VERMONT AGENCY OF TRANSPORTATION
 CITY OF MONTPELIER
 PROJECT NO. BHF 6400(31)

GUIDED EXPANSION POT BEARING DETAIL

AMSCOT
 STRUCTURAL PRODUCTS CORP.
 DOVER, NJ JOB # 3371

FOR WINTERSET INC. SHEET NO. 1 OF 2

ANCHOR BOLT DETAIL
QTY. REQ'D = 8, 4 PER BEARING

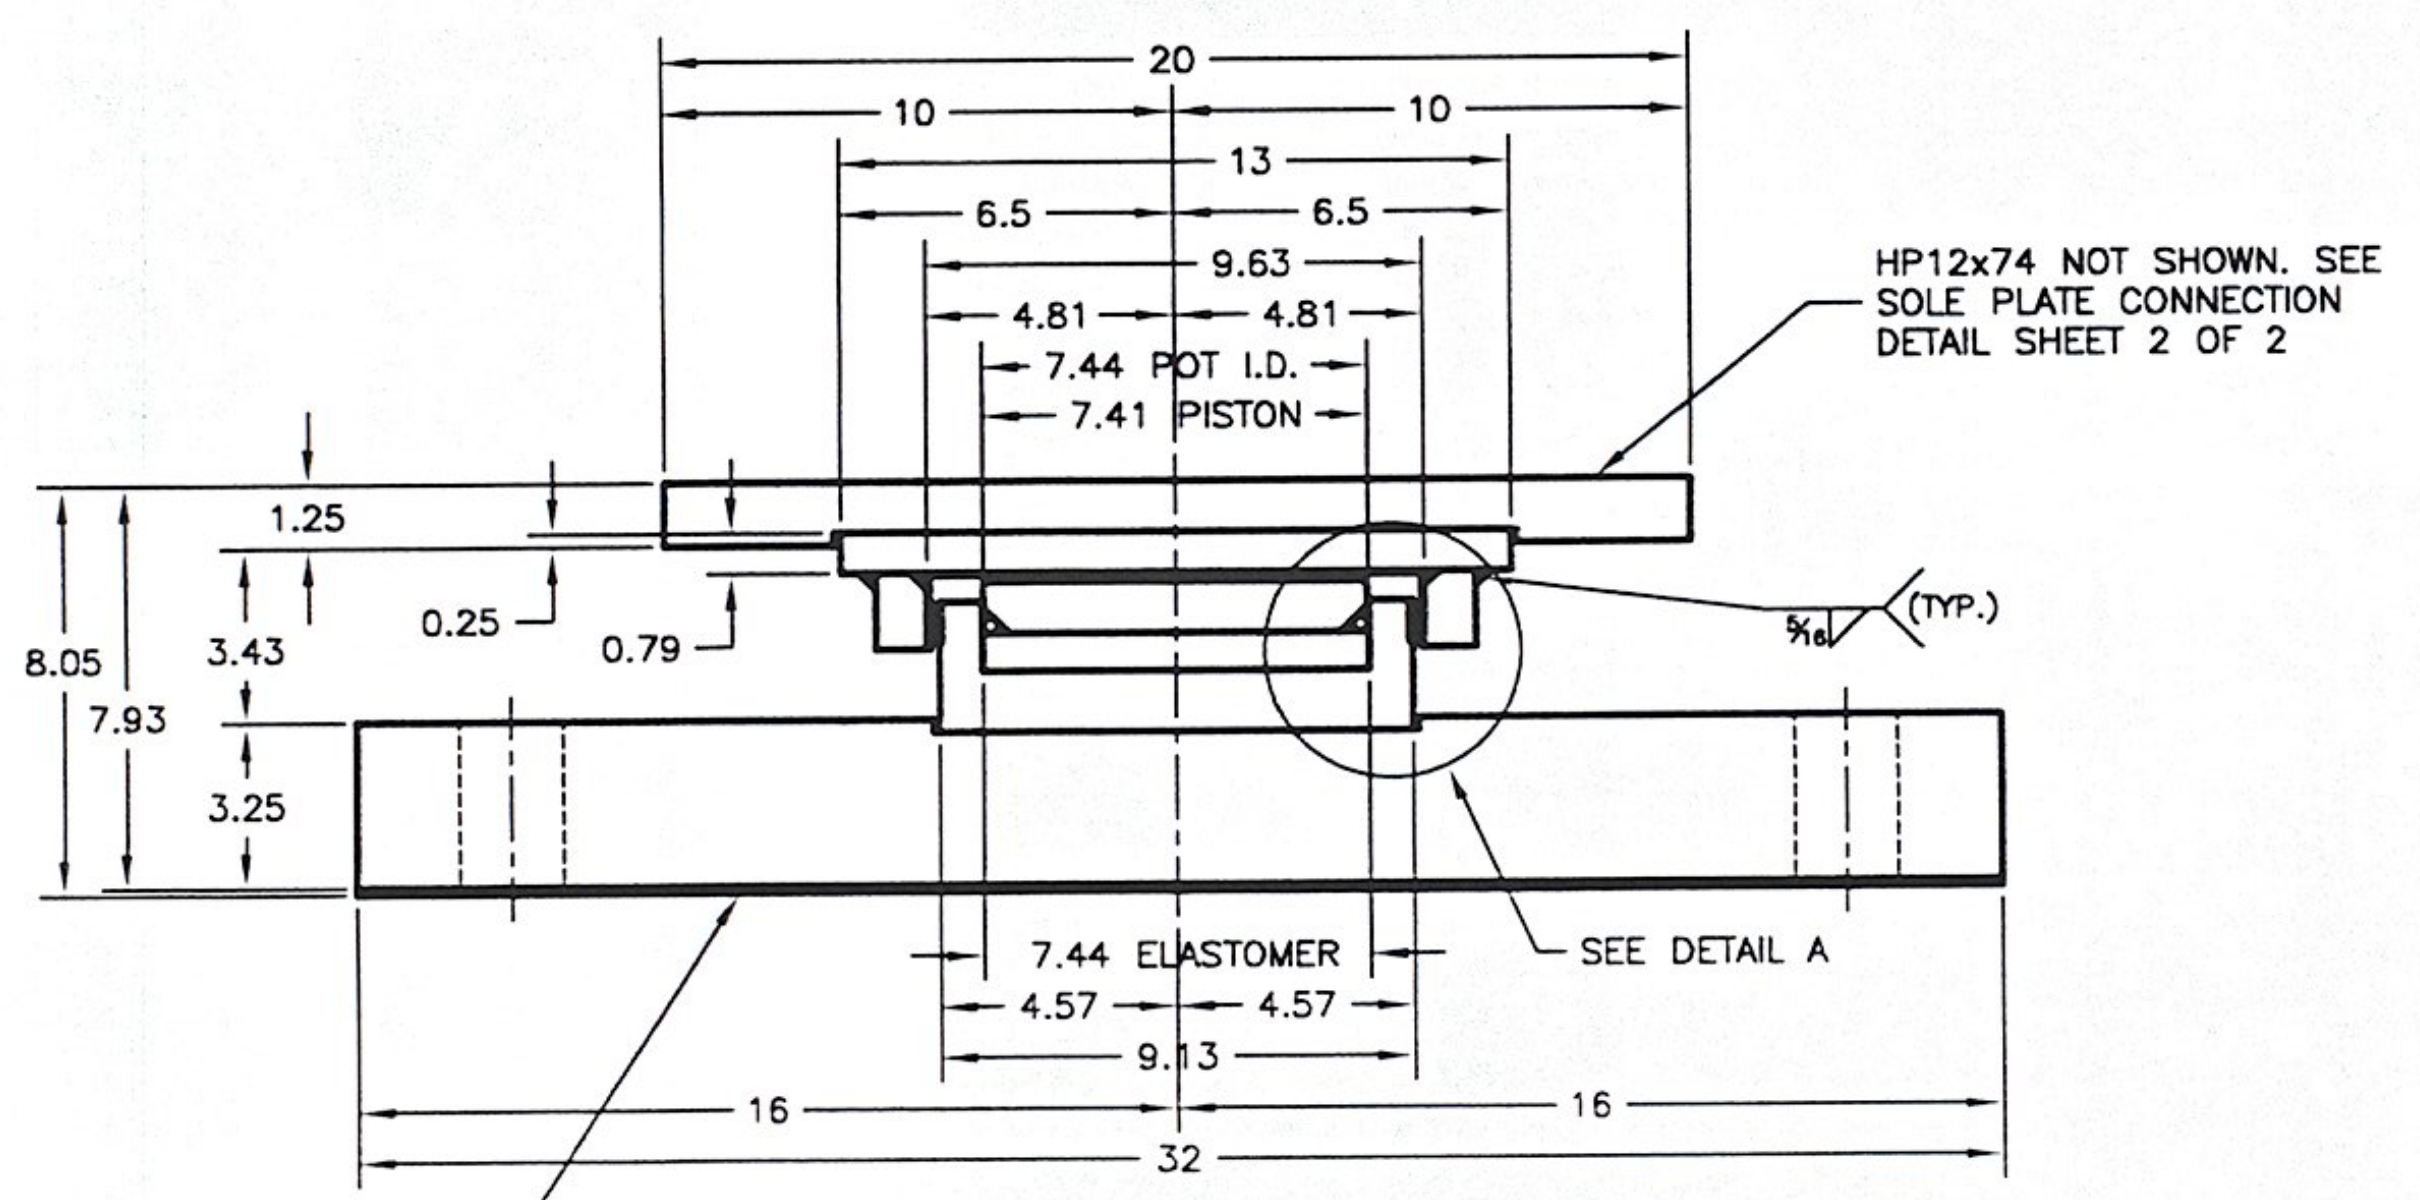
PROVIDE EMB. LENGTH + PROJECTION TO ENSURE ADEQUATE GRIP.

GUIDED TYPE @ ABUTMENT 2
 QTY. REQ'D = 2
 ITEM NO. 531.1200
 VERTICAL CAPACITY = 150 KIPS
 HORIZONTAL CAPACITY = 14 KIPS

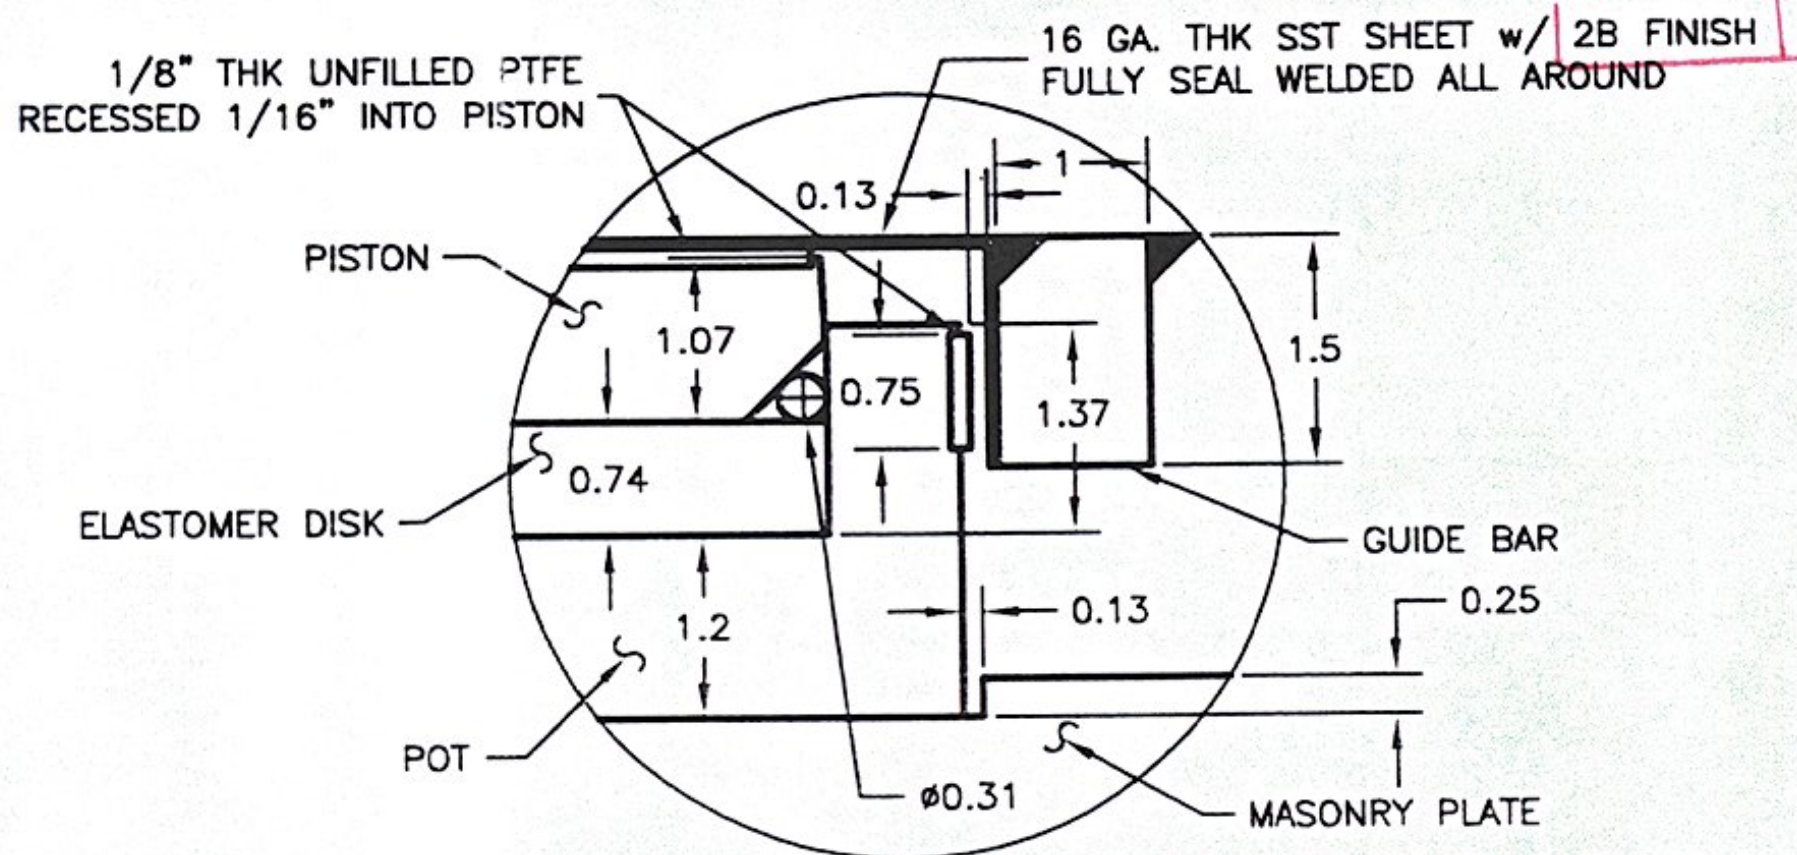
OR ONLY TOTAL LOADS = 209K

OR 10% OF VERTICAL LOAD IN ACCORDANCE W/ 531.04 (h)
